# ***PRODUCT UPDATE***

## **5R110W TorqShift**

### **Delayed Forward Engagement**

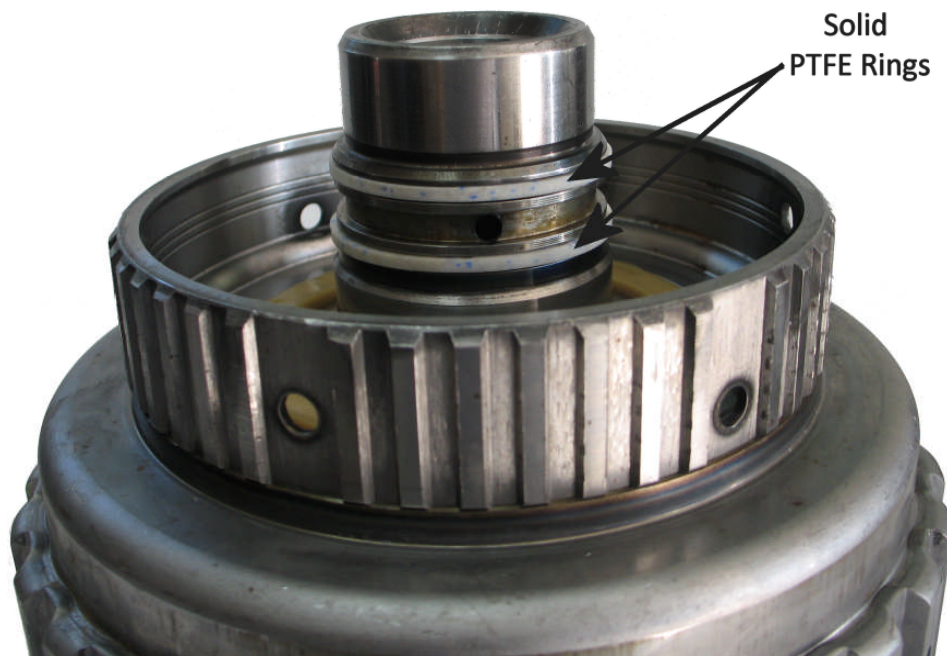
The following update has been added to our overhaul kits, built with date codes of 8/27/2007

The current production style sealing rings are a known concern to the technical services, as being the cause of *delayed forward engagement*.

The two solid PTFE sealing rings found in this kit use the same installer and resizing tools as the solid PTFE rings used for the 4L60-E stator support for the reverse input clutch.

The solid PTFE ring ensures the best possible seal in this application as it eliminates the need for oil pressure to snap the ring out against the bore which then creates the seal.
